## REQUEST FOR SARA RESPONSE

### LOT 2, CAPTAIN COOK HIGHWAY, PORT DOUGLAS

SARA reference: 2503-45404 SRA  
Council reference: CA 2025\_5732/1  
Applicant reference: C1302

## SARA referral agency response – Captain Cook Highway, Port Douglas

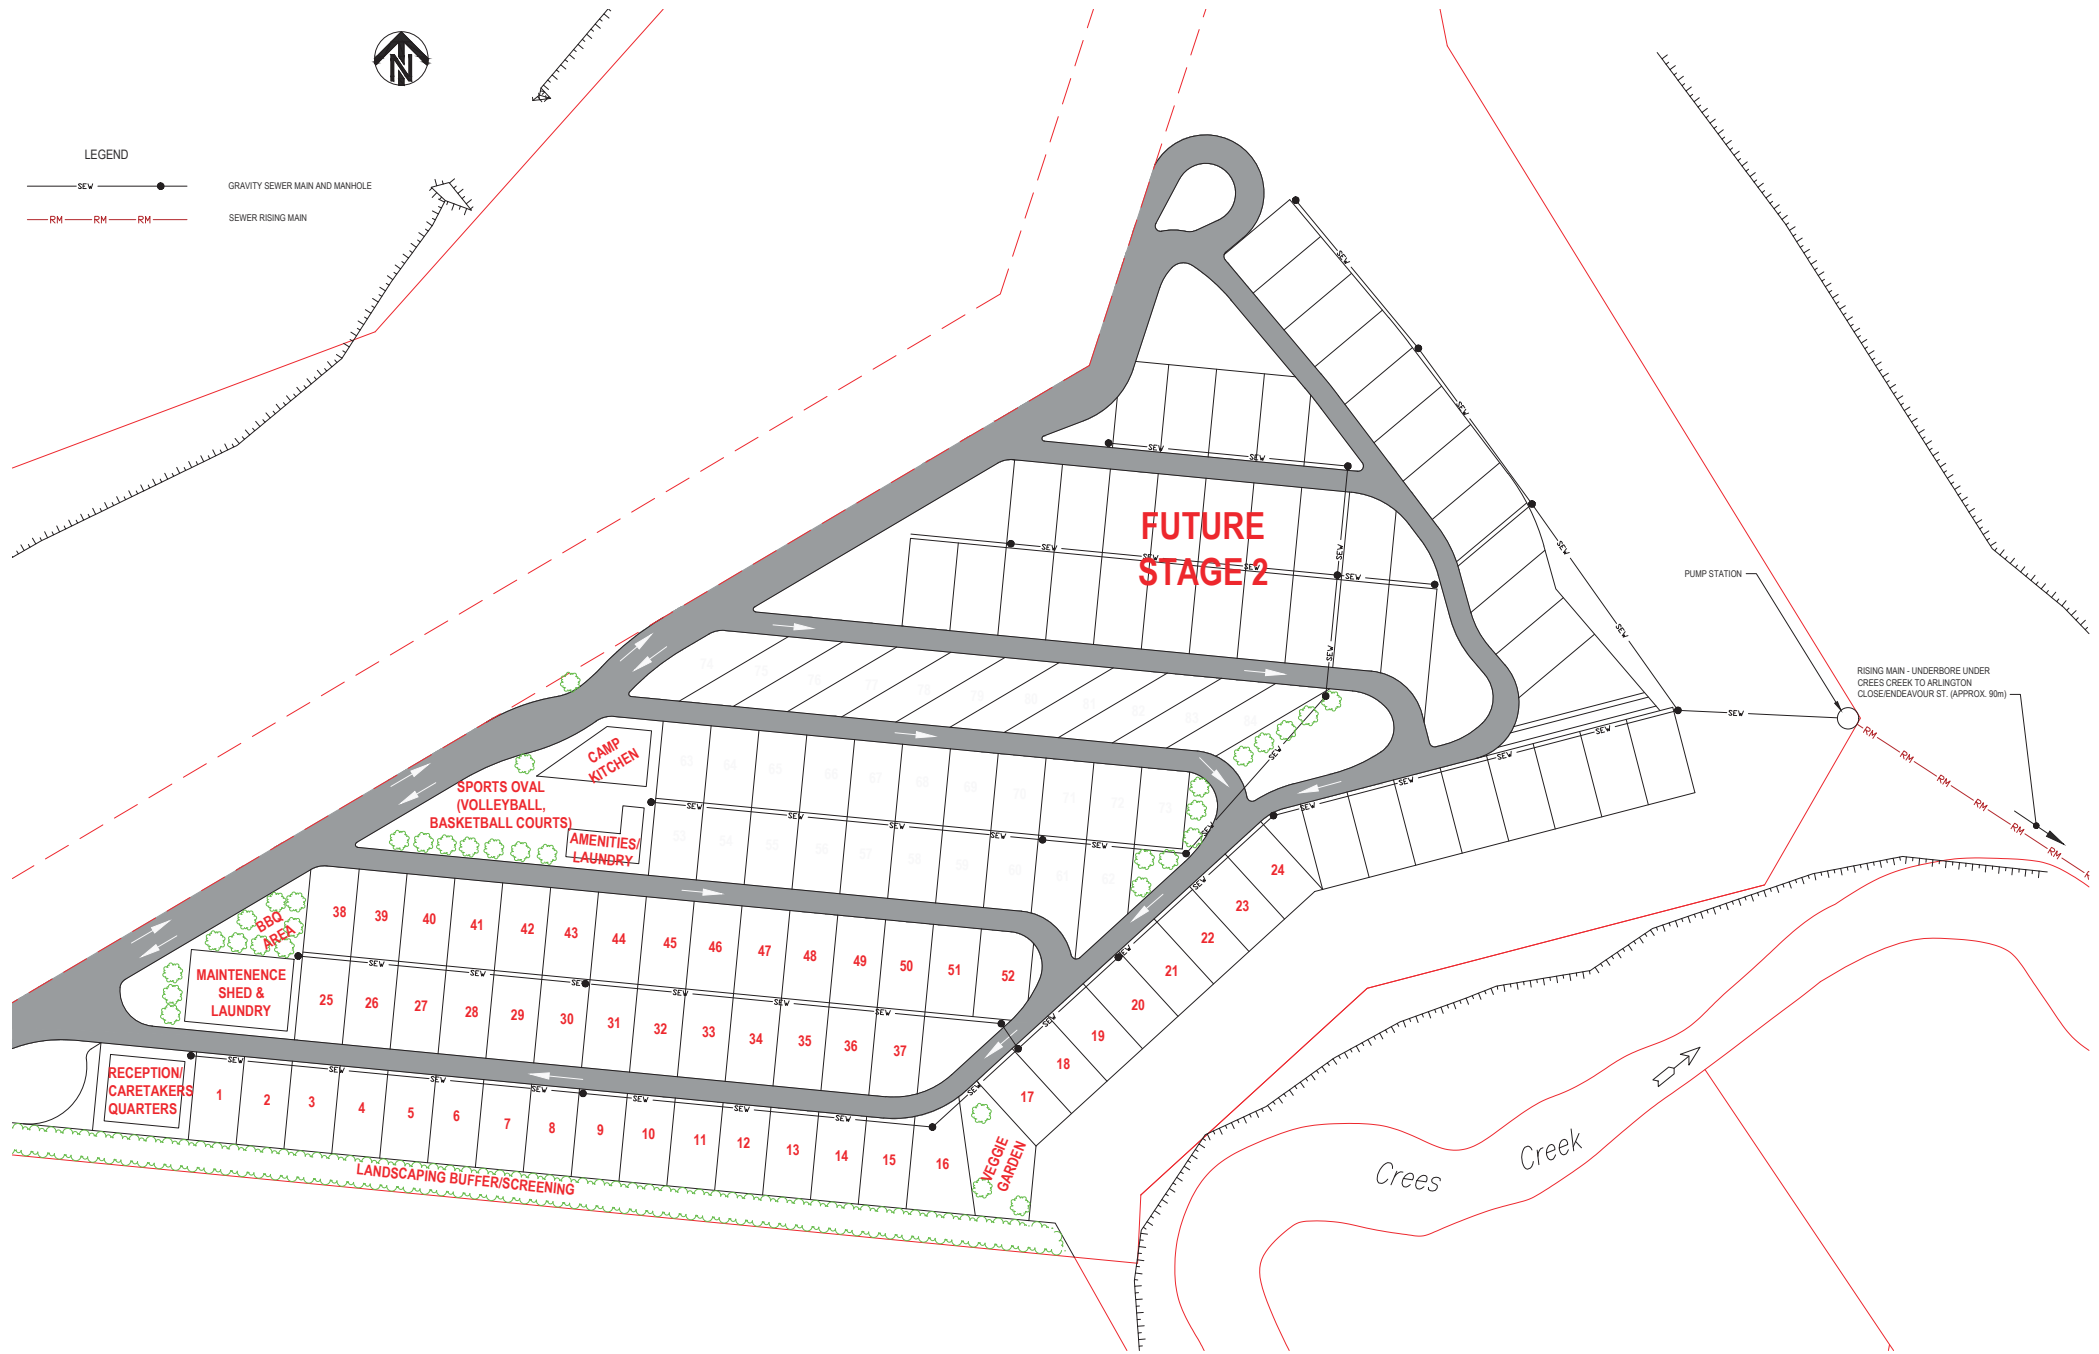
As part of further investigations, it was determined that it would be more efficient and cost-effective to provide a connection to the existing sewer network in Endeavour Street to the north east – refer to **Attachment E – OSE Group Plan**.

To enable this connection, it is proposed to establish an on-site pump station and part of the sewer main within the "buffer area" of the subject site. This section is within the Erosion Prone Area allocation of the SARA Coastal Protection mapping.

FIGURE 1  
PROPOSED SEWER ALIGNMENT  
– TENURE CONSIDERATIONS  
NOVEMBER 2025

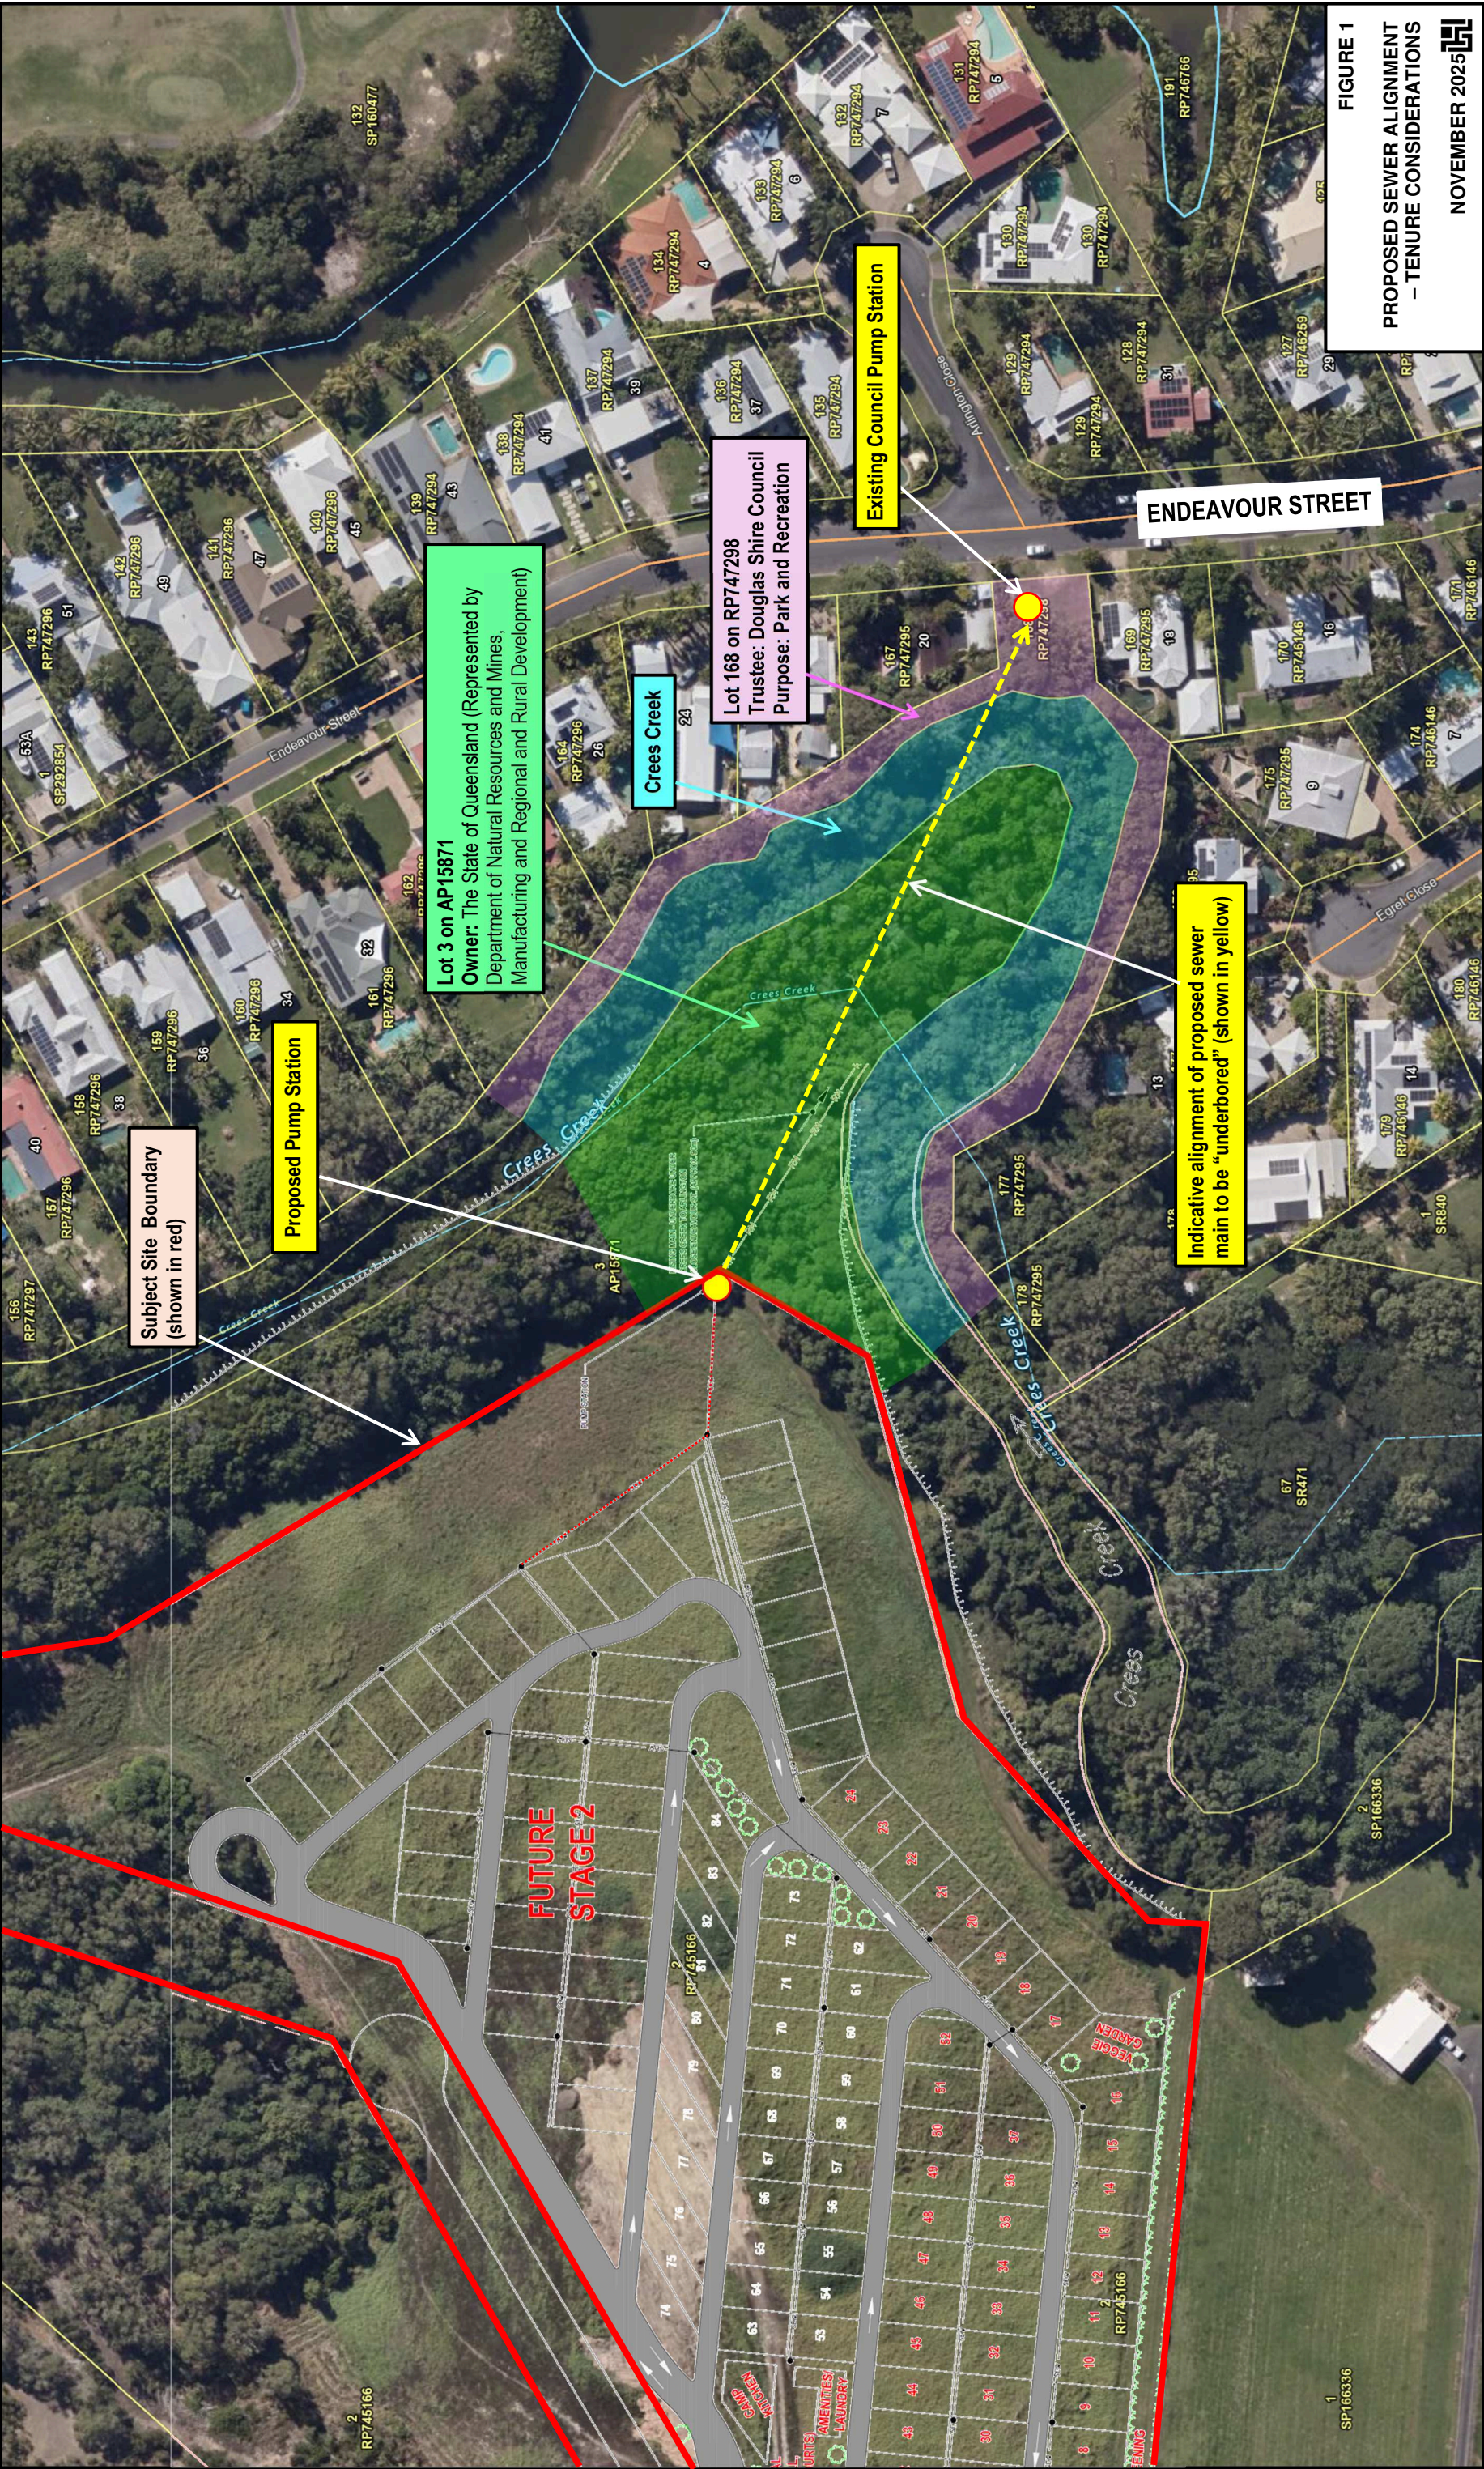
It is proposed to "underbore" the entire section of the sewer main connection from the on-site pump station to the existing Council pump station adjacent to Endeavour Street. This will minimise impacts on the existing waterway and vegetation.

The section of the proposed sewer main alignment located outside the subject site and to be underbored is located within the following lots:-

The relevant tenure considerations for the proposed sewer alignment is shown by **Attachment H – Proposed Sewer Alignment – Tenure Considerations**.

- a) it is acceptable to SARA that the proposed sewer main alignment from the Subject Site to the existing Council pump station in Endeavour Street can be established by "underboring" Lot 3 on AP15871, the lot parcel containing Crees Creek and Lot 168 on RP747298;
- b) further item a) above, the proposed sewer main alignment does not create any additional referral triggers for this application in relation to the establishment of the pump station and sewer main in the Erosion Prone Area allocation;
- c) there is in-principle support for the proposal; and
- d) given the nature of the works for infrastructure that landowner consent for the works is not required

- b. Sewer infrastructure – It is understood that a future operational works application will be lodged with the Douglas Shire Council to facilitate the intended sewer infrastructure that will be necessary to service the proposed development as shown on the plans provided at Attachments E & F. Given the extent of works to install the sewer main located outside of the subject land parcel (Lot 2 on RP745166) are intended to be carried out via the practice of 'underboring', this is not considered as being assessable development under Schedule 10, Part 17 of the Planning Regulation 2017.

2. Sewer infrastructure – It is understood that a future operational works application will be lodged with the Douglas Shire Council to facilitate the intended sewer infrastructure that will be necessary to service the proposed development as shown on the plans provided at Attachments E & F. Given the extent of works to install the sewer main located outside of the subject land parcel (Lot 2 on RP745166) are intended to be carried out via the practice of 'underboring', this is not considered as being assessable development under Schedule 10, Part 17 of the Planning Regulation 2017.
